## SERVICE BULLETIN No. 324

B' AND 'C' RANGE PUSH ROD COVER TUBE OILING SEALING (1969/1970) MODELS)

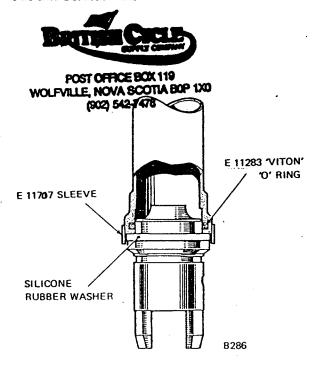
Remove the push rod cover tubes, and check the upper and lower flanges for squareness by rolling on a flat surface. Position a cadmium-plated sleeve, part number E 117d7 over the lower end of each cover tube. In most cases the sleeve will be a tight fit, but if necessary a proprietary bonding agent can be used to secure it. (See diagram for correct positioning of sleeves).

An additional sealing washer should be fitted over each tappet guide block to prevent leakage. The purpose of the sleeve is to control any tendency for the washers to 'squeeze out' when the cylinder head is tightened down.

Use the latest type of 'Viton' (black rubber) 'O' ring seals, part number E 11283. Position one seal in the recess at the lower end of each cover tube, and one in each recess in the cylinder head.

Fit the head gasket and position the cylinder head on the block. Press the head downwards to ensure that the seals are seated correctly. Before tightening the cylinder head bolts measure the clearance between the head and gasket. This must be between 0.030–0.040". If the clearance is not correct, adjust the thickness of the white silicone rubbers accordingly.
